STANDARD FIELD SERVICE BULLETIN

FSB Number	CHRAEFSB2014-108
Author	Anthony Bryan
Date	10/28/2014
Subject	XT1254 Droid Turbo - Rear Camera - Can't Launch
Model Affected	XT1254
Level Of Repairs	Level 2

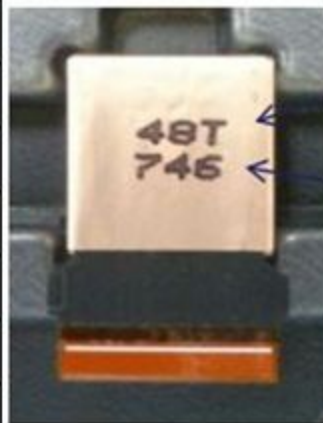
Engineering analysis of the devices found that the 20MP Rear Camera Module (Service P/N: 01017884001) was not functioning due to internal connection issues caused by either weak ACF Bonding or Solder Residue Transfer. This is a component fabrication issue at the camera supplier.

1. Following Service Manual, carefully disassemble device to gain access to 20MP Rear Camera Module (Service P/N: 01017884001).
2. Inspect the part markings to determine if it is affected by this symptom. See affected Date Code/Lot Code image below.
 - a. If affected, replace 20MP Rear Camera Module (Service P/N: 01017884001) and resume normal repair process.
 - b. If not affected, then this bulletin does not apply. Follow normal repair procedures.

Date	Lot
492	7EA
493	7EY
493	7EZ
493	7ET
493	7F3
49F	95Z
49F	955
49H	9A9
49G	970
49F	95Y

The camera supplier has implemented process improvements to resolve these issues as of October, 2014.

Purge existing inventory of the 20MP Rear Camera Module (Service P/N: 01017884001) and scrap affected date codes. See affected Date Code/Lot Code image above.
